RFP #2024-18
ADDENDUM #02
Issued August 27, 2024

SYRACUSE HANCOCK INTERNATIONAL AIRPORT SURFACE PARKING LOT EXPANSIONS - LOT #3 DESIGN

SITEMAP RECORD EXHIBIT

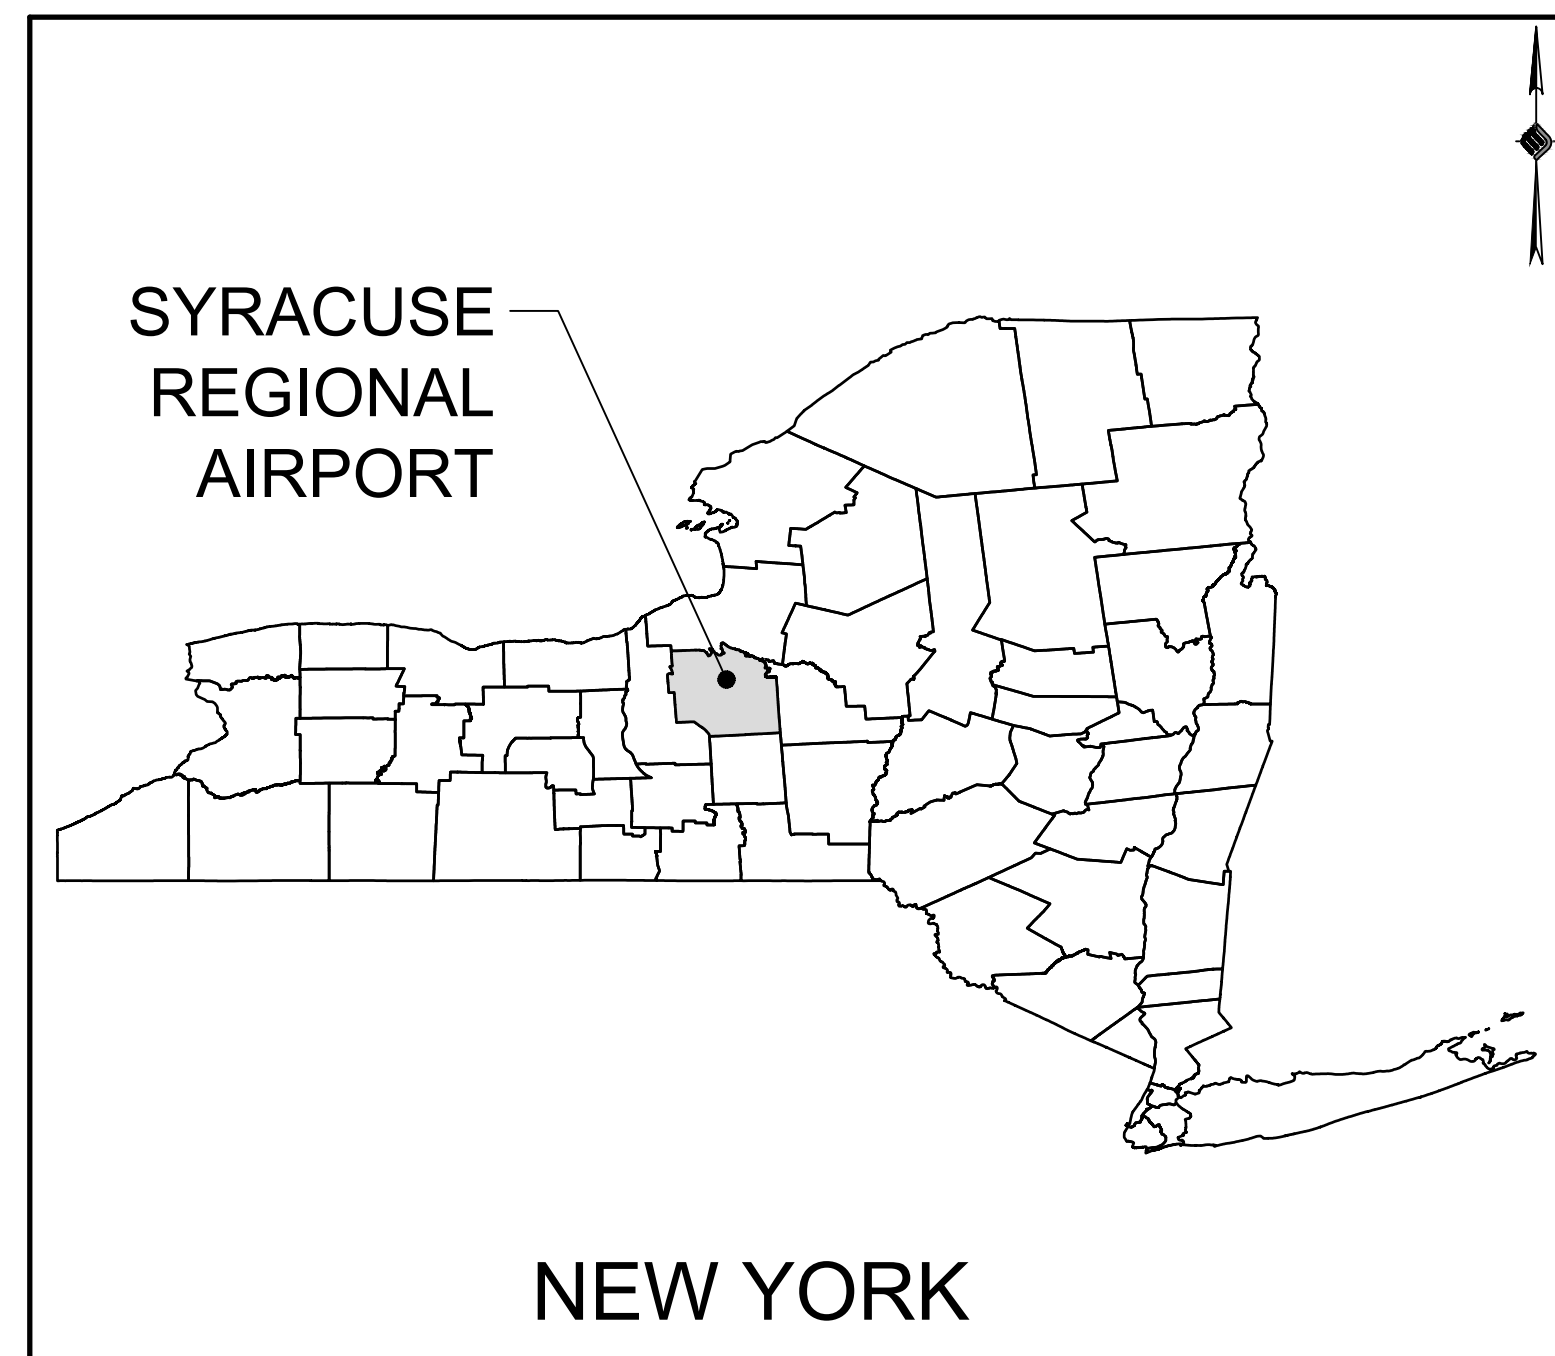
Could you please provide the GPR data from the site?

Please see attached GPR data for both the surface lot and add-alt maintenance lot.
